Access Design Assessment Report

62 Old Barrenjoey Road
Avalon NSW 2107

Project: 62 Old Barrenjoey Road Avalon
 Document Type: Access Design Assessment Report
 Report Number: P219_269-2 (ACCESS) YW

Figure 1 – Stairway to the entrance doorways of the units on the first floor

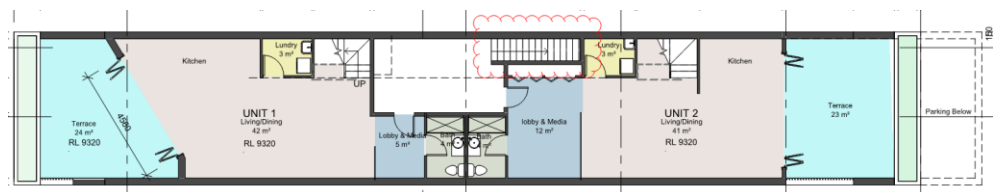
Access to and within the Class 2 part is proposed to be provided via a single stairway only to the entrance doorways of the units on the first floor.

Whilst the proposed access to the Class 2 part has been identified, compliance is readily achievable via a performance-based solution that would demonstrate compliance with the relevant performance requirement/s of the BCA.

- Class 2 part must be provided from a pedestrian entrance to the entrance door to at least one floor containing sole occupancy units and to the entrance doorway of each sole occupancy unit located on that level (excluding those areas identified within Section 2.3 above).
- Class 6 part is to be provided to and within all areas normally used by occupants (excluding those areas identified within Section 2.3 above).
- Class 7a part, where accessible car parking space/s are provided (excluding those areas identified within Section 2.3 above).

Figure 2 – Proposed central stairway

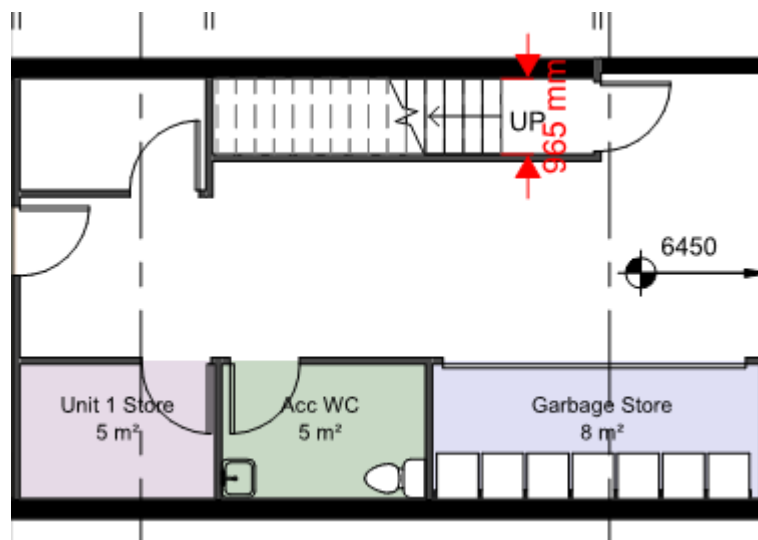
- (i) The main accessway of the retail tenancy is under sized, an 850mm clear door width (920 door leaf) is required.
- (ii) The stairway connecting between floors provides for both communication and egress, the following provisions are required for DA:
 - Minimum 1000mm unobstructed width;
 - Handrails to both sides;
 - Appropriate handrail extensions top and bottom of the stairway;
 - TGSIs to the top and bottom of the stairway,

Figure 3 – Main entrance doorway and internal stairway of the retail tenancy

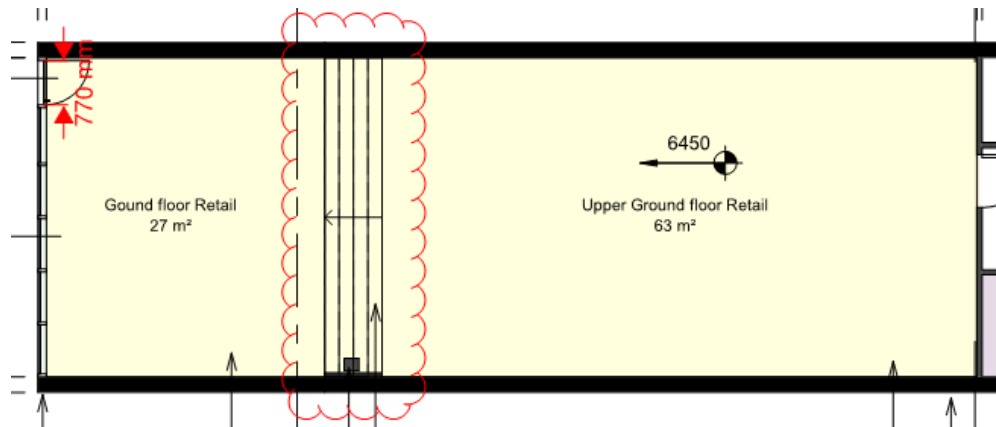
- (iii) The stairway serving the internal split level of the Class 6 tenancy is not shown to be provided with handrails each side of the stairway and TGSI's at each level landing.

Whilst the above issues have been identified as deficiencies, compliance is readily achievable via the design development. However, the principle entrance of the retail needs to be revised to be compliant as outlined above prior to DA submission.

Figure 4 – Location of the stairway platform lift

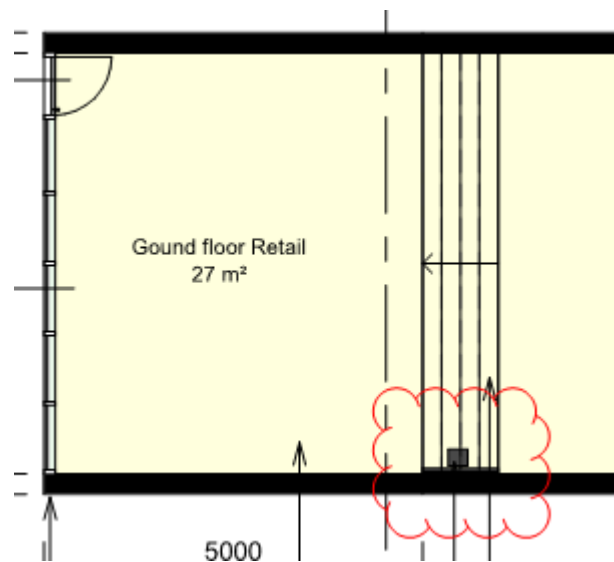
The stairway platform lift within the retail tenancy must comply with the following -

- (i) Be an approved type identified in Table E3.6a;
- (ii) Have a lift floor dimension of not less than 810mm wide x 1200mm deep;
- (iii) Not rely on a constant pressure device for its operation if the lift car is fully enclosed;
- (iv) Have a passenger protection system in accordance with Clause 4.2 of AS1735.12-1999.

Detail such as lift specification shall be provided within future design progression for compliance assessment and comment.
